LOCAL IMPACT REPORT

A46 Newark Bypass Scheme

Nottinghamshire County Council
October 2024

Figure 13 Example of fence positions which do not appear to be viable (in yellow)

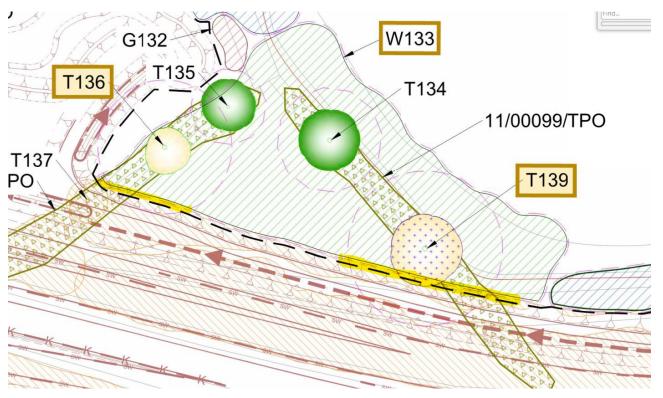
- 6.42 The sheet orientation of the drawings is not consistent, for example sheet 9 is portrait and not landscape.
- 6.43 T136 (veteran), T139 (veteran) (see Figure 1 below), T144, T214, T217, G131, G129a and G223 (as examples there may be other instances): The tree protection measures conflict

with the footprint of the proposed earthworks indicating that the tree protection measures are not viable. Earthworks often require a) working space beyond their footprint, b) a 'toe' where excavation is necessary and c) potentially temporary works to address/amend ground levels beyond the footprint of embankment. It is not clear that the assessment has taken this into account and is it therefore questionable if the AIA/TPP is a realistic interpretation of the likely impact of the Scheme.
